SERVICE BULLETIN	
PRODUCT:	Washing Machine
BULLETIN NUMBER:	ASC20160907001
BULLETIN DATE:	9/7/2016
MODELS:	WF42H5200AF/A2 WF42H5200AP/A2 WF42H5200AW/A2 WF42H5000AW/A2 WF42H5600AP/A2 WF42H5600AW/A2 WF42H5400AF/A2 WF42H5400AW/A2

SUBJECT: Door is not locking properly.

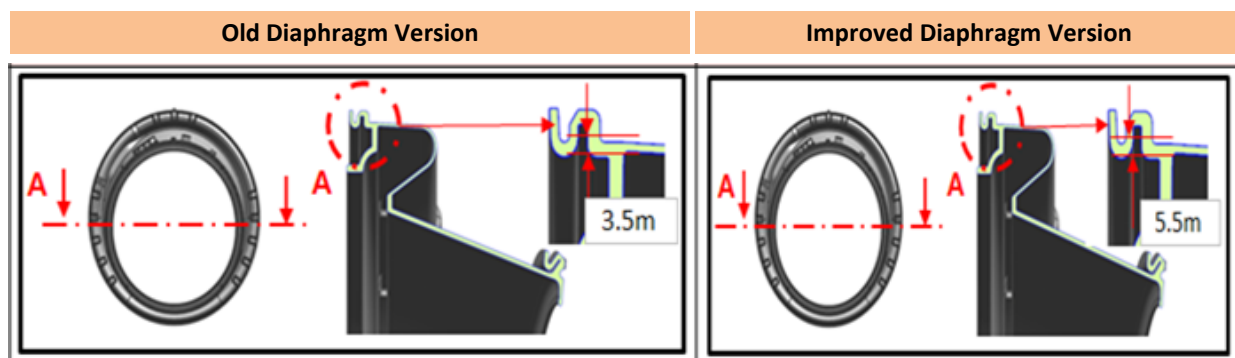
- Door locking error displayed.
- Improper door locking operation.

- Replace the improved Assy Diaphragm with a new Assy Diaphragm: DC97-18094B or DC97-18094C.

- If the unit production date is before June, 2016, replace the currently installed Assy Diaphragm with a new Assy Diaphragm.
- If the diaphragm is not replaced, the door locking issue will re-appear.
